Product Change Notification

Type of Notification: Changing a Component

LHA30F
, LHA50F
, LHA75F
, LHA100F
, LHA150F
, LHA300F-

Table 2.2 Appearance of "Existing" and "Changed" (example)

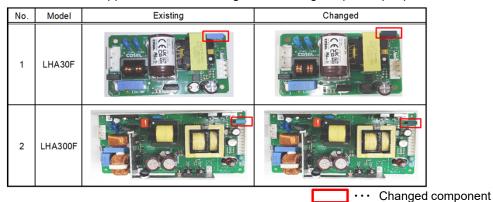
Following component becomes discontinued, and an equivalent component will be replacing it (See table below). This change does not affect electronic specifications, nor does it affect safety standards compliance.

Table 2.1 Description of Change						
No.	Parts	Model	Parts No.	Contents	Existing	Changed
1	Film Capacito r	LHA30F LHA50F	C521	Manufacturer	PILKOR	OKAYA
				Type Name	PCX2339D6G233 (other name:PCX2339S60164)	LE233
				Rated Voltage [VAC]	305	275
		LHA75F LHA100F	C530	Capacitance[µF]	0.022	0.022
				Capacitance Tolerance[%]	±10	±10
				Temperature Range[°C]	-55 - 110	-55 - 100
				Color	Light Blue	Black
		LHA150F LHA300F	C509	Apperance	22m K 1057-72 m 3399/1000 2243 K (Factors) 13957-	LE223 0.022#KXZ 275V~ZI
